# UNITED STATES PATENT AND TRADEMARK OFFICE

| APPLICATION NO. | FILING DATE | FIRST NAMED INVENTOR | ATTORNEY DOCKET NO. | CONFIRMATION NO. |
|-----------------|-------------|----------------------|---------------------|------------------|
| 09/585,682      | 06/01/2000  | Kei-Yu Ko            | 3526.2US(97-1136.2) | 7481             |

# Office Action Summary

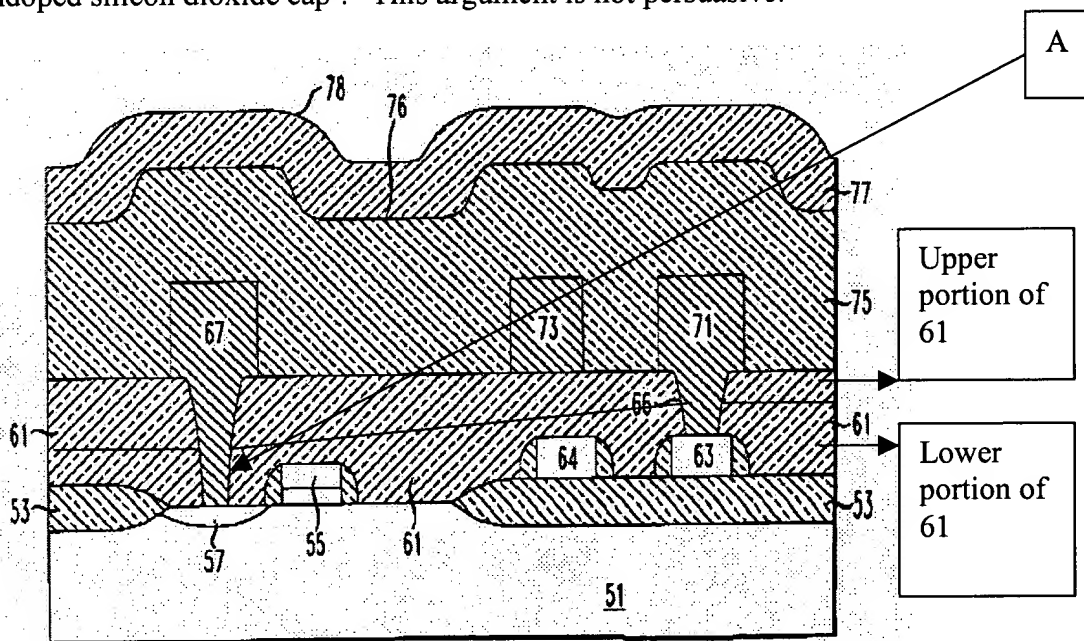
On page 6, applicant argues "it is respectfully submitted that the windows 66 and 67 of the semiconductor device described in Cargo and shown in Figs. 2, 4 – 6, and 8 thereof do not include sidewalls which extend 'substantially perpendicular' relative to the substrate 51 thereof. To the contrary, FIGs. 2, 4 – 6, and 8 of Cargo depict the windows 66 and 67 as having curved sidewalls which are oriented at a variety of nonperpendicular angles relative to the substrate 51." This argument is not persuasive. Since the term "substantially perpendicular" is broad language, any angle that is almost perpendicular to the semiconductor substrate read as "substantially perpendicular". Therefore, the term "substantially perpendicular" clearly does not structurally distinguish over Cargo et al.

Furthermore, applicant argues "it is respectfully submitted that the description of Cargo (see FIGs. 2, 4-6, and 8) is limited to a semiconductor device which includes windows 66 and 67 with sidewalls that extend continuously and in uninterrupted fashion through dielectric 61, including both the upper doped silicon dioxide portion thereof and the lower, undoped silicon dioxide portion thereof. Thus, Cargo does not expressly or inherently describe that any portion of any of the sidewalls of window 66 or 67 terminates at an undoped silicon dioxide section of dielectric 61. As such, Cargo neither expressly nor inherently describes 'at least one contact aperture' with 'at least one sidewall' that includes 'at least a portion' which 'terminat[es] at [an] undoped silicon dioxide cap'." This argument is not persuasive.

Since the point (A in the above figure) clearly shows the sidewall (at the right side of the element 67) of the contact aperture terminates at the side surface of the undoped silicon dioxide cap (Lower portion of 61), hence Cargo et al. meets the limitation, at least one contact aperture with at least one sidewall that includes at least a portion which terminates at an undoped silicon dioxide cap, as required in claims 1 and 6.

For the above reasons, the rejection is maintained.
